SUBJECT: SAFETY RECALL OF 2022~2025 MB TOURRIDER COACHES

Ref.: NHTSA recall reference # **25V-TBD**
DCNA Bulletin # **TI 91.10T25237A**

TITLE: Tourrider USA – stop (fixate stop) not mounted on backrest of ISRI driver’s seat

91.10T25327A - Coach, ~~Fixate-Stop~~ stop not installed on backrest of ISRI driver's seat delivery package
Recall

Fixate-Stop stop not installed on backrest of ISRI driver's seat delivery package

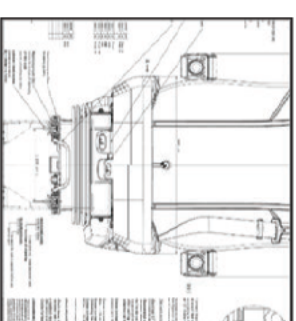
The prescribed stop is not mounted on the backrest of the ISRI driver’s seat.

Assembly error in a limited production period at production site in Turkey.

Retrofit solution for recall

RETROFITTING

Torque: 22 NM ± 2Nm

Pay attention to the correct orientation of the component!
